RMC70E Revision History and Notes

Project Name: **RMC75E**

Part Number: **EAA0700**

Sheet Name: **Memory**

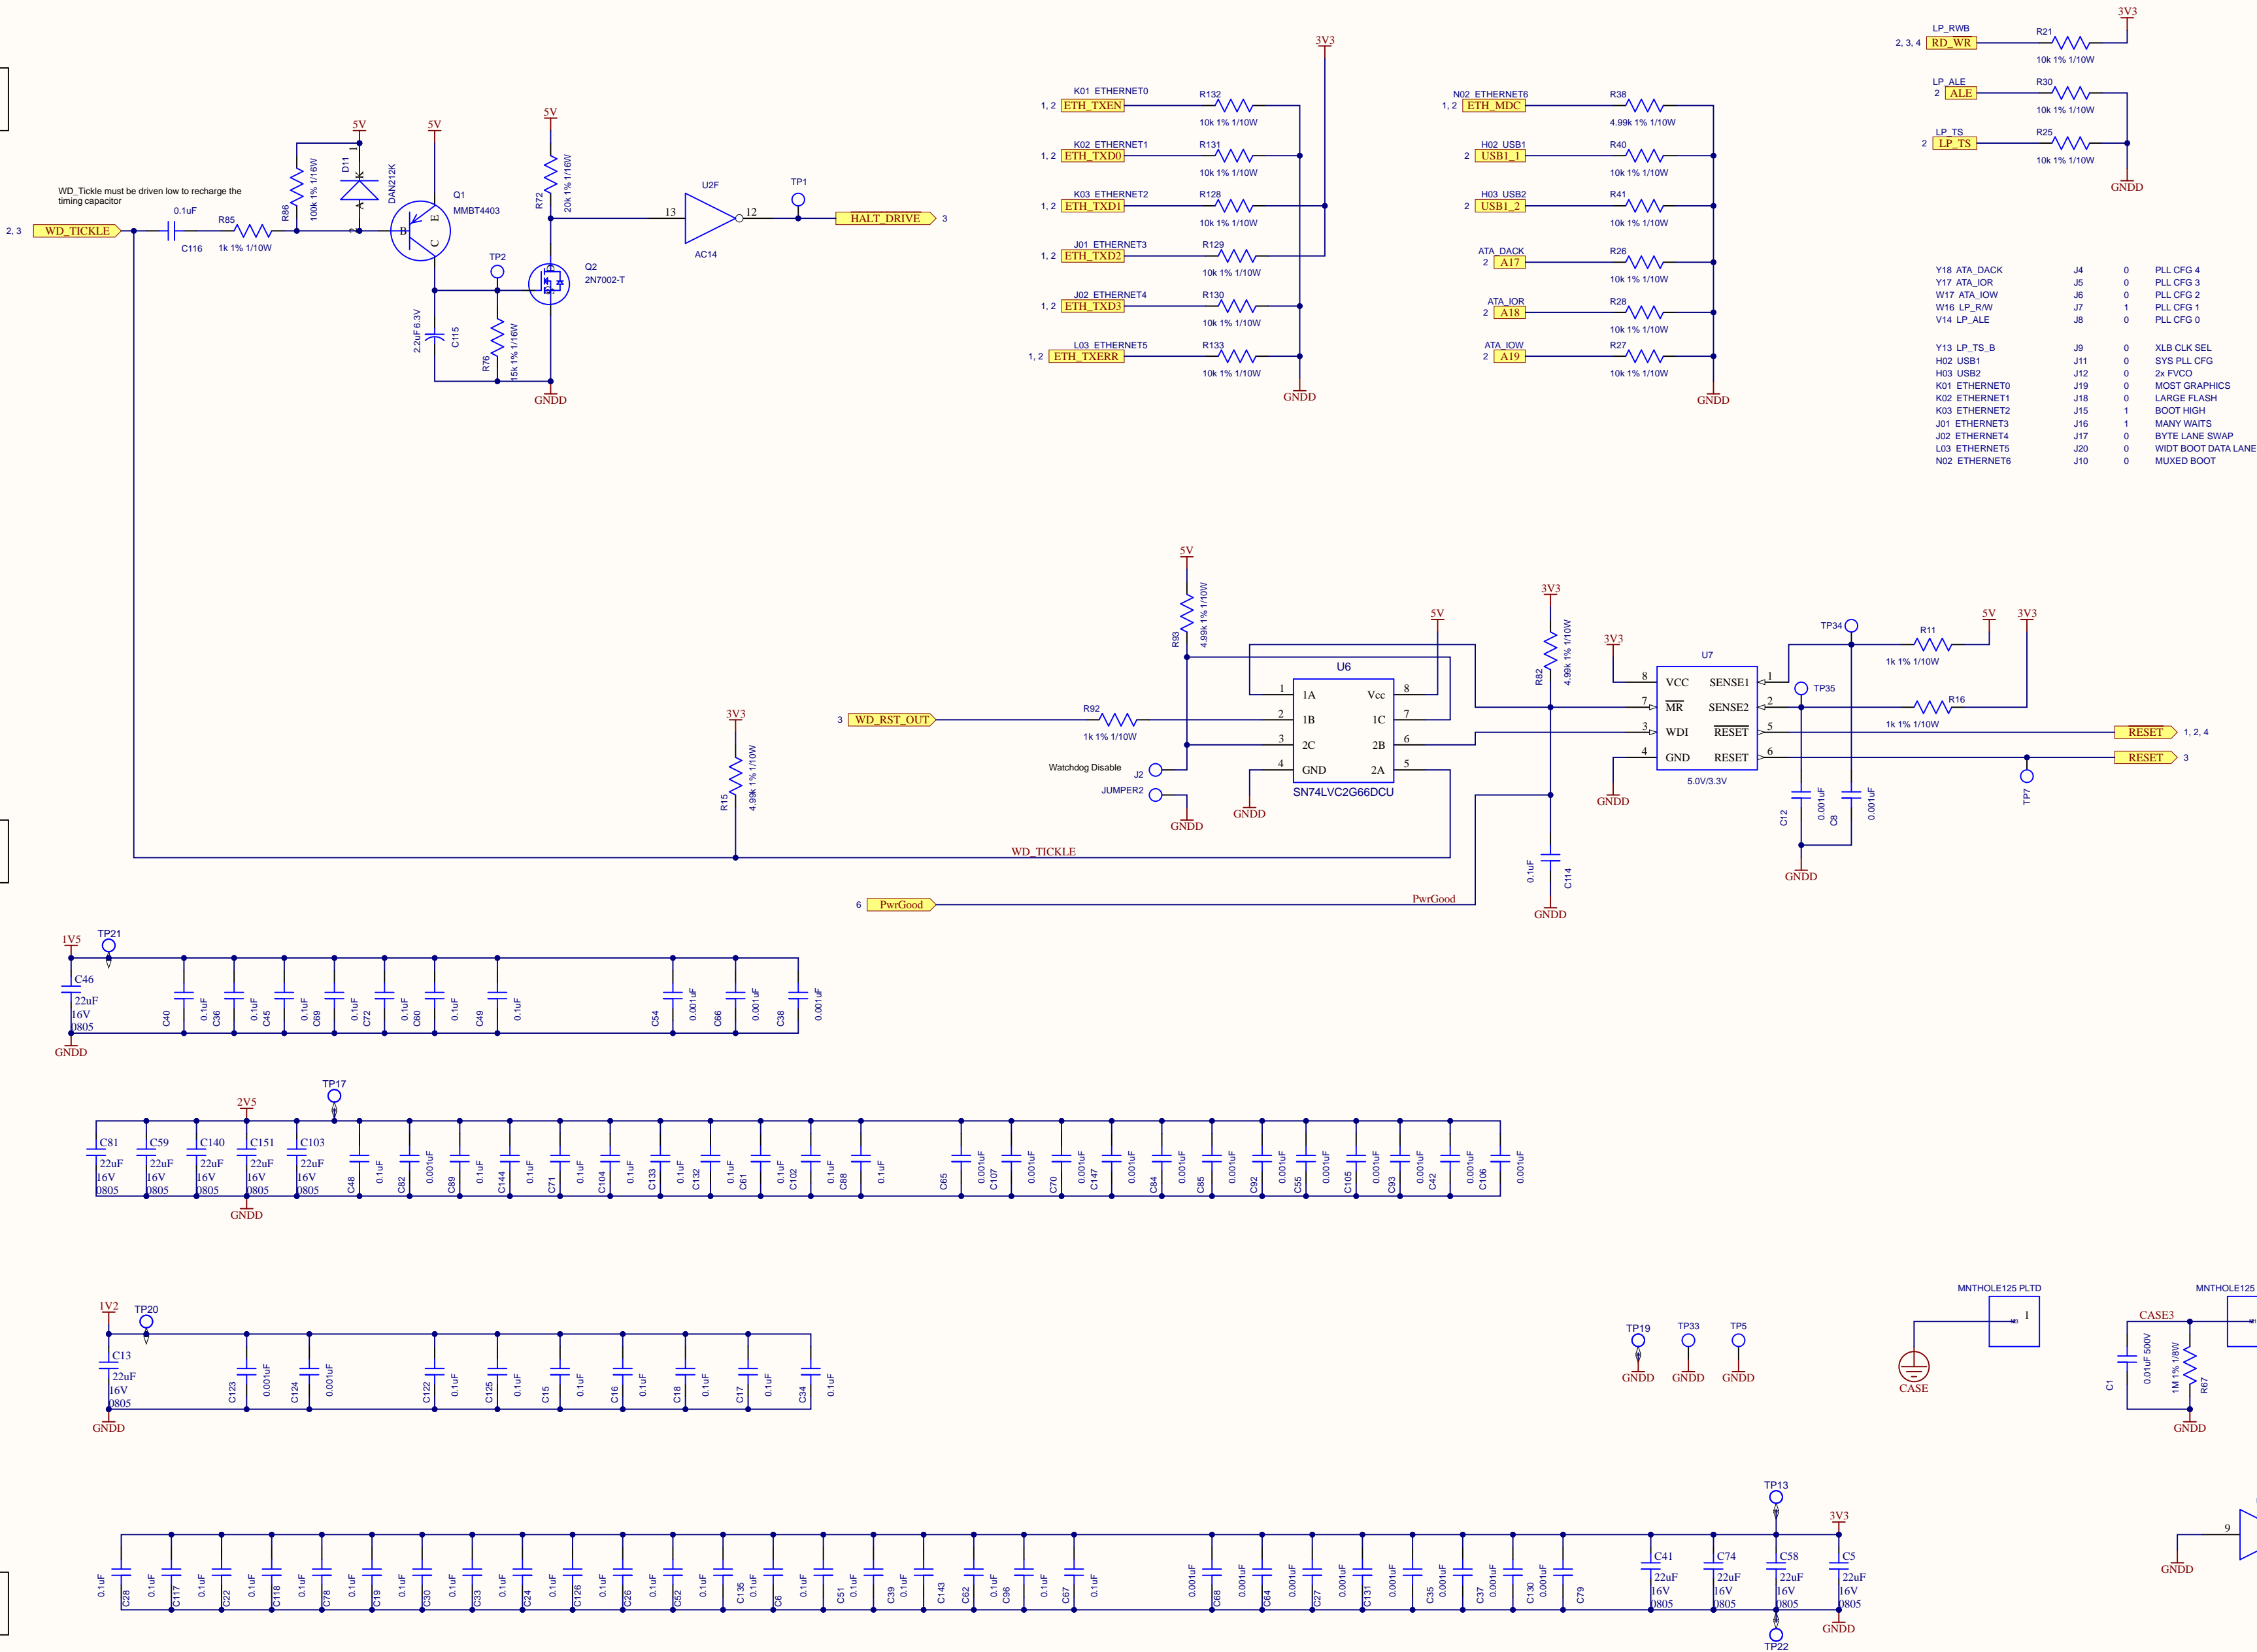
In rev 2.x, the 1.8V power rail was removed from the design. This power rail also supplies 1.8V to the Expansion port. This is not being used by any of the existing Expansion modules at this time.
